State University of New York College at Cortland
Old Main ADA Bathroom Upgrades
Project No. 20240032

ADDENDUM NO. 1

Addendum

01

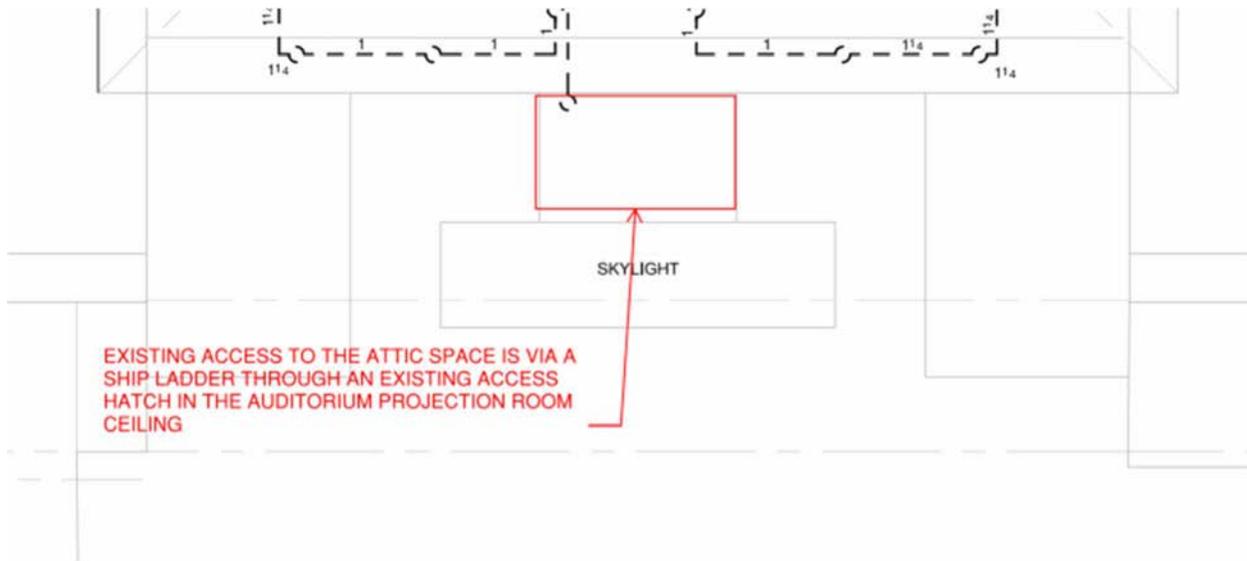
1. On Drawing FPD103, West Side of the drawing (top of page), **replace** the west side of the central plan fire protection demolition plan with the following sketch showing the existing conditions and scope of removals in the space directly above the auditorium:

2. On Drawing FPD103, adjacent to the replacement sketch above, add the following notes to the plan:

- “A. MUCH OF THE EXISTING FIRE PROTECTION PIPING SERVING THE AUDITORIUM SPACE IS INSTALLED ALONG AND BELOW THE FLOOR OF THE ATTIC SPACE, UNDER THE EXISTING INSULATION AND UNDER AREAS OF EXISTING PLANKING NAILED DOWN OVER ATTIC FLOOR JOISTS. CONTRACTOR SHALL CUT PLANKING BETWEEN JOISTS AND PULL UP THE INSULATION AS NECESSARY TO ALLOW FOR THE REMOVAL / REPLACEMENT OF THE EXISTING DRY SYSTEM PIPING SERVING THE AUDITORIUM SPACES. THE EXISTING PERIMETER CATWALK AND ASSOCIATED FALL PROTECTION SHALL BE PRESERVED AND MAINTAINED TO THE EXTENT POSSIBLE.

- B. IN ADDITION, TO FACILITATE THE FIRE PROTECTION SYSTEM REPLACEMENT IN THE AUDITORIUM, THE AUDITORIUM SHALL BE PROVIDED WITH AN OPENING INTO THE ATTIC TO ALLOW FOR THE REMOVAL OF THE EXISTING FIRE PROTECTION SYSTEM, AND FOR THE STAGING AND INSTALLATION OF THE NEW DRY FIRE PROTECTION PIPING SYSTEM. THIS MAY BE ACCOMPLISHED BY CREATING AN OPENING THROUGH THE EXISTING AUDITORIUM ARCHITECTURAL CEILING FINISH, AND REPAIRING TO SAME CONDITION UPON COMPLETION OF WORK, OR ACCESS MAY BE GAINED THROUGH EXISTING WALL LOUVERS AND EXISTING GRAVITY AIR INTAKES ON THE WEST SIDE OF THE BUILDING. THIS WILL REQUIRE REMOVAL AND REINSTALLATION OF LOUVER AND BIRD SCREENING INTO THE ATTIC SPACE.

- C. THE CONTRACTOR SHALL REQUIRE A LIFT/SCAFFOLDING TO MAKE PIPING REMOVALS AND NEW INSTALLATION / CONNECTIONS AT THE AUDITORIUM CEILING DRY FIRE PROTECTION SYSTEM HEADS, AND TO SUPPORT ANY SUBSEQUENT PATCHING AND PAINTING. REMOVE EXISTING AUDITORIUM CHAIRS AS REQUIRED TO FACILITATE THE LIFT AND CEILING WORK. THERE ARE NO EXISTING POWER/LIGHTING CONNECTIONS TO THE CHAIRS, ONLY MECHANICAL FASTENING TO THE AUDITORIUM FLOOR.

- D. SEE GENERAL NOTE FOR ADDITIONAL CLARIFICATIONS REGARDING FINISHES. ALL WORK SHALL PRESERVE ALL REQUIRED FIRE RATINGS.”

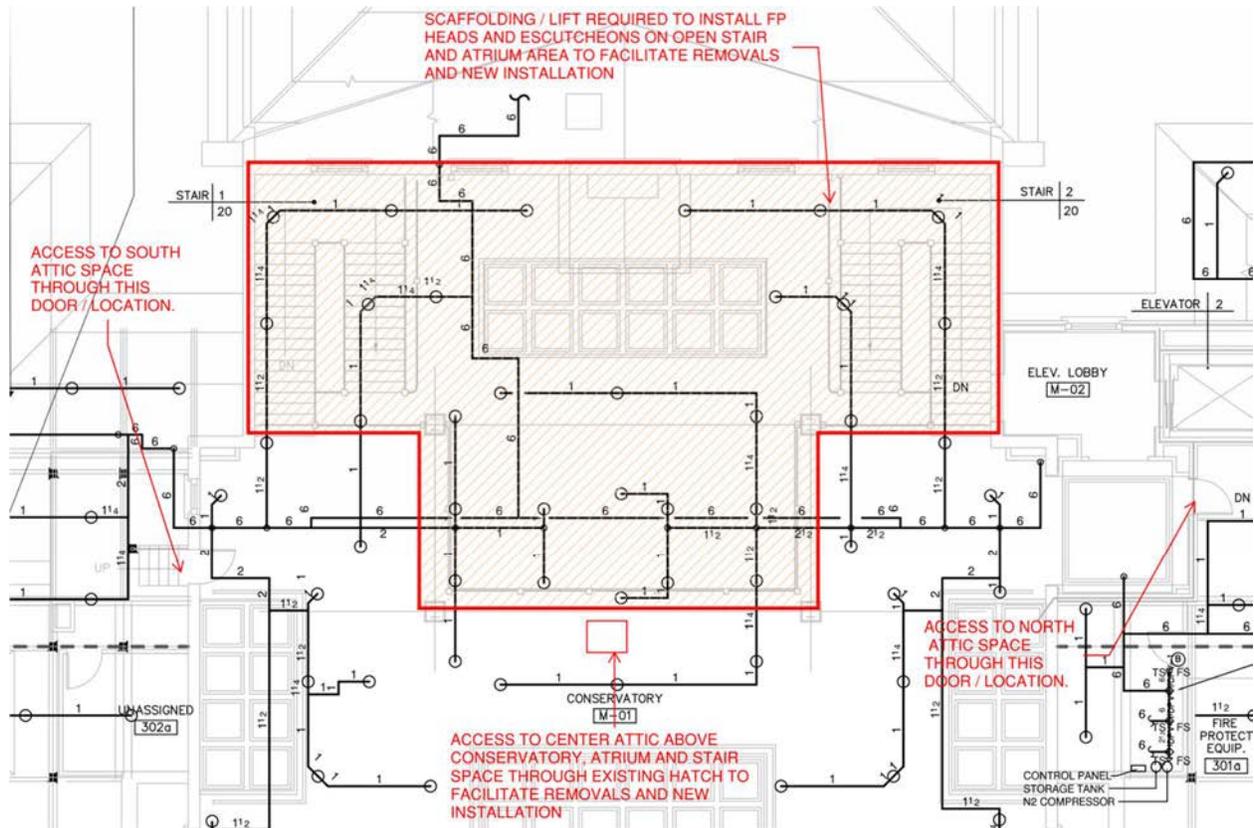
3. On Drawing FPD104, **add** the following note to the Auditorium Attic – Fire Protection Plan 1-

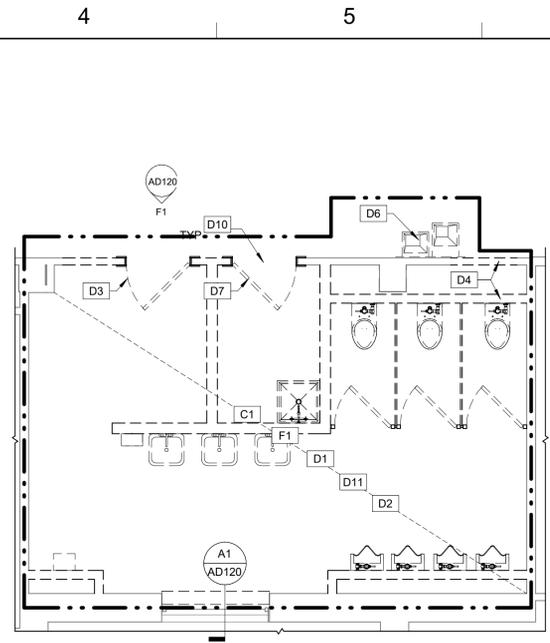
7. On Drawing FP103, West Side of the drawing (top of page), **replace** the west side of the central plan fire protection demolition plan with the following sketch showing the proposed dry fire protection system layout (replacing the existing piping in kind) in the space directly above the auditorium:
